York Street Interchange

Public Inquiry
Technical Paper

City Reparo Alternative
Design Proposal

10 November 2015

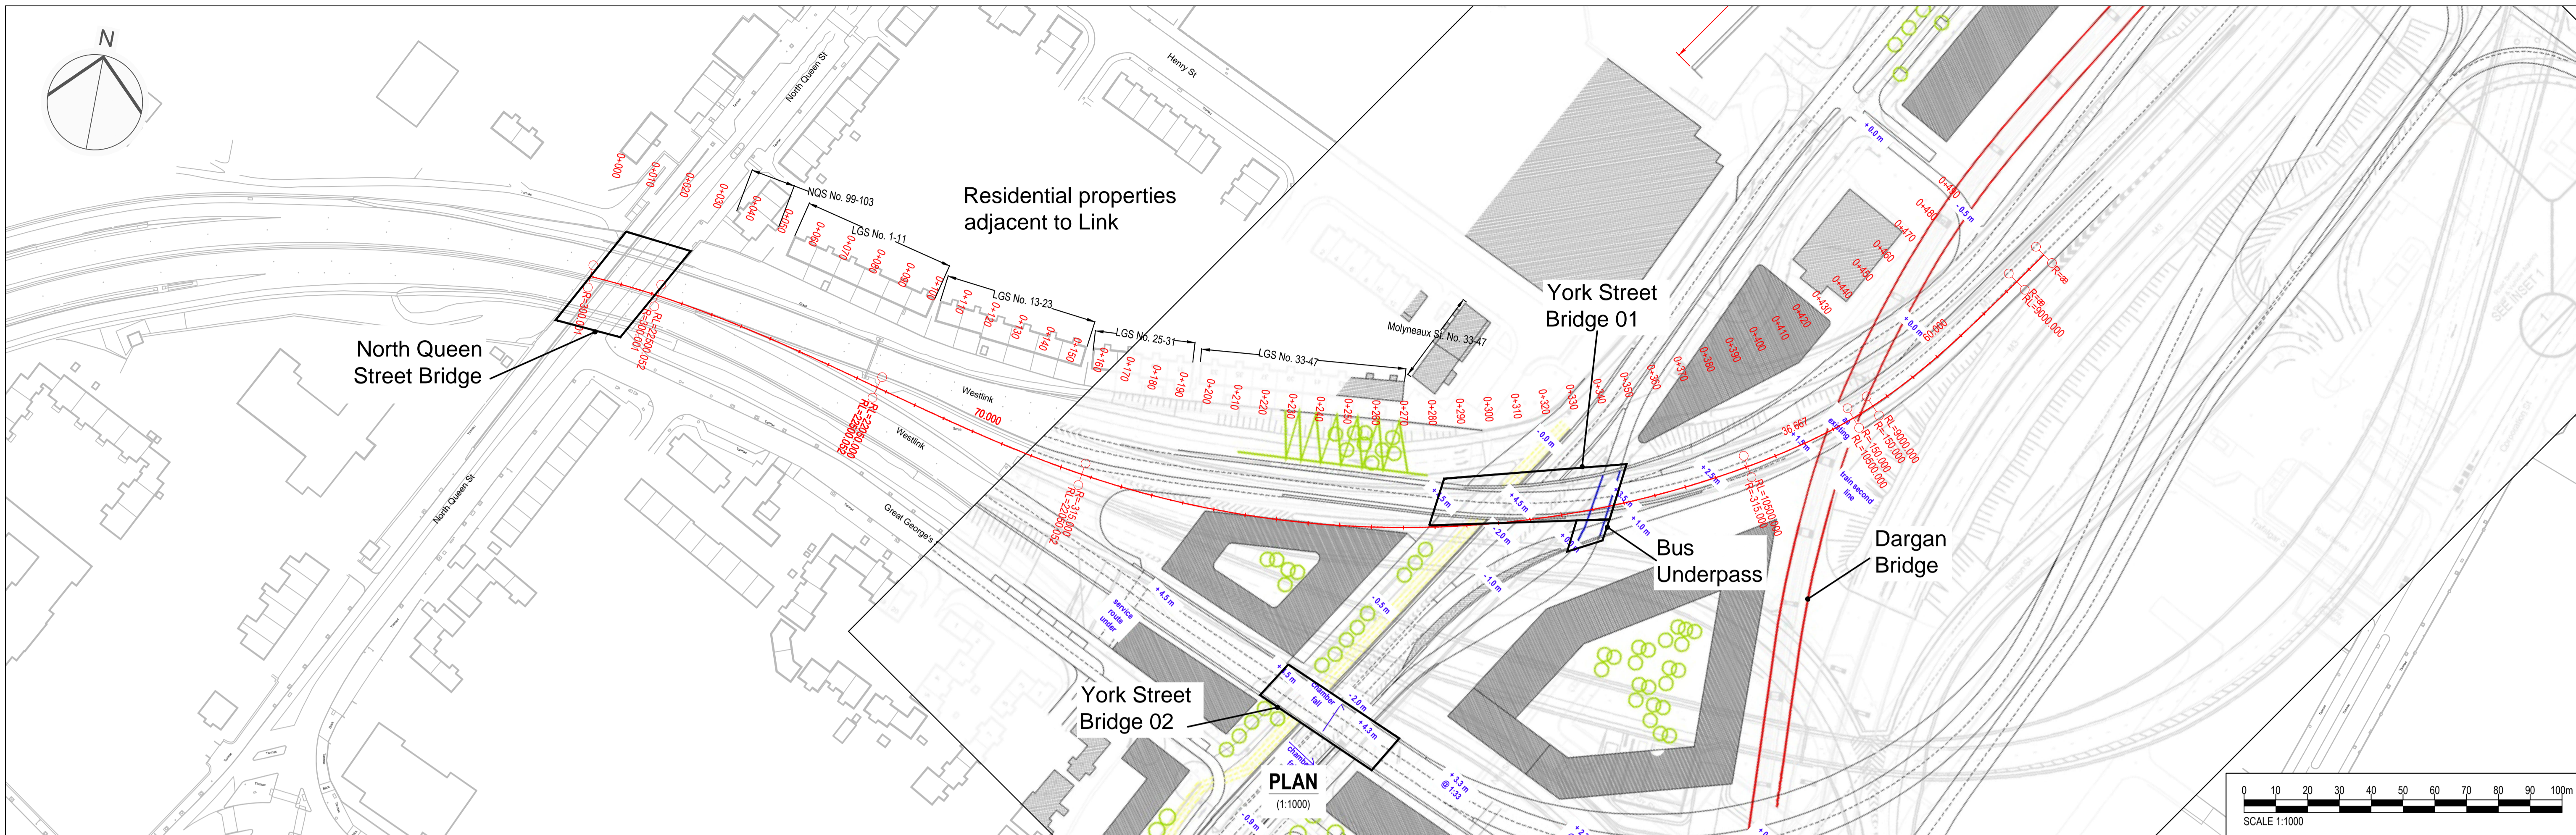
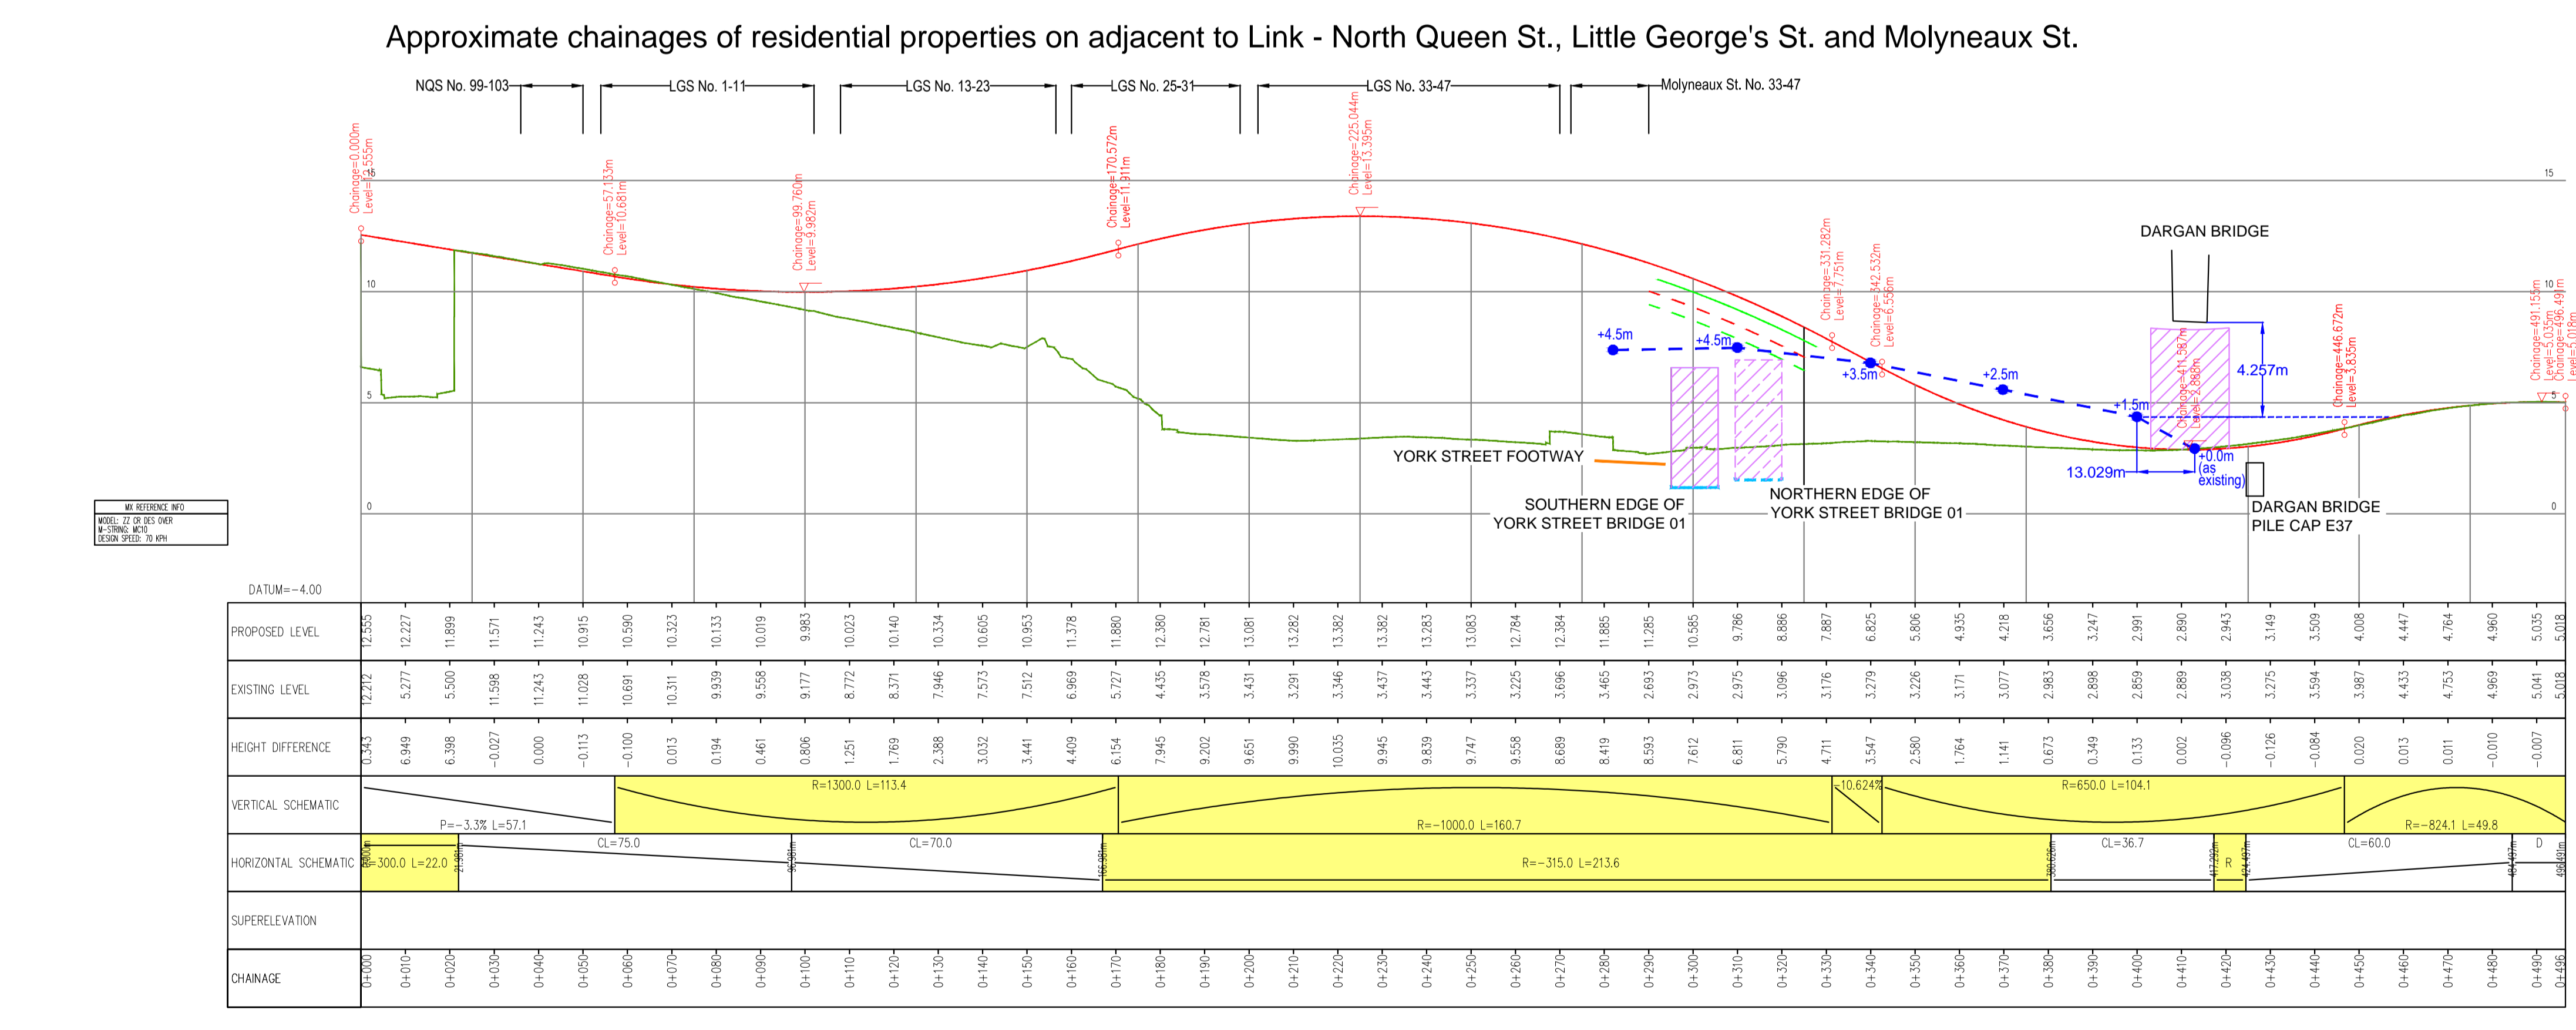
- Significantly, at the eastern end of the Westlink to M2 alignment, the CRP identifies that the road alignment FRL would be 1.5m higher than existing ground level (EGL), approximately 13m away from the proposed tie in point under the Dargan Bridge. With reference to the survey information, this would put the FRL at approximately 4.4mAOD, relative to the typical ground level of 2.9mAOD. Even if this could be provided without the use of vertical curves, this would create, over the 13m distance, a downhill gradient of 11%, significantly in excess of the 6% Desirable Maximum gradient allowed by DMRB Standard TD 22/06 for interchange design.

- The CRP vertical alignment of the Westlink to M2 link would be higher than existing ground level on the section between North Queen Street bridge and York Street underpass, i.e. the section of carriageway running parallel to Little Georges Street. An indication of the increase in FRL, relative to EGL, for a range of the existing properties at Little Georges Street is presented below:

- Nos. 1 to 11, -0.11m to +0.8m increase in FRL relative to EGL
 - Nos. 13 to 23, +0.8m to +4.4m increase in FRL relative to EGL
 - Nos. 25 to 31, +4.4m to +9.6m increase in FRL relative to EGL

- Nos. 33 to 47, +9.6m to +8.7m increase in FRL relative to EGL.
- City Reparo have claimed that the Proposed Scheme would have an illegal impact on the existing properties at Little Georges Street due to the changes in road level and position blocking natural daylight to rear windows. This claim has been proven incorrect by the daylight assessment completed by TransportNI in accordance with legal guidelines. In the Proposed Scheme, the road level of the Westlink is raised by a maximum of 4.5m, with the largest increase being at house nos. 33 to 47. Elsewhere, the raising of the road alignment is more modest, typically up to 650mm.

- The profile of a best-fit CRP alignment (to overcome the noted problems with headroom with the original submission) would have a much more significant increase in road level past all the houses. The necessary embankments and/or structures to support this raised road alignment would therefore have a much worse impact on daylight levels to properties at Little Georges Street than the Proposed Scheme. It is likely that the CRP would potentially impact upon the residents' legal right to light.
